## DEVELOPMENT REVIEW COMMITTEE MINUTES

July 1, 2014

ENGINEER REVIEW COMMENTS  
CANYON SUBDIVISION PHASE 2  
950 SOUTH CANYON ROAD

PLAN RECEIVED DATE:	JUNE 17, 2014
PLAN REVIEW DATE:	JUNE 30, 2014
DATE RETURNED TO DEVELOPER:	JULY 1, 2014

## Proposed Changes - Housing

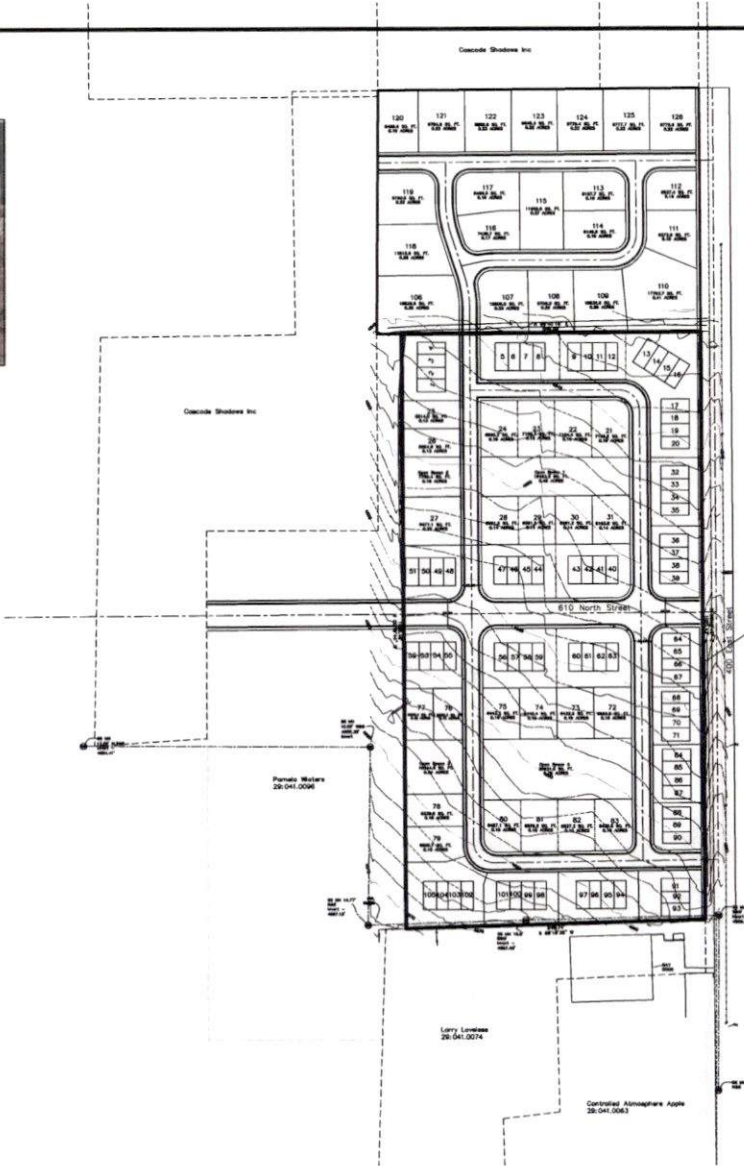
### Major Changes

Use	Previous	Proposed
High Density Area	109 Units (7.7 u/a)	92 Units (12.4 u/a)
High Density Use	Twinhomes & Clustered Single	Townhomes
Single Family	135 Units (2.8 u/a)	94 Units (1.7 u/a)
Total Units	244	186
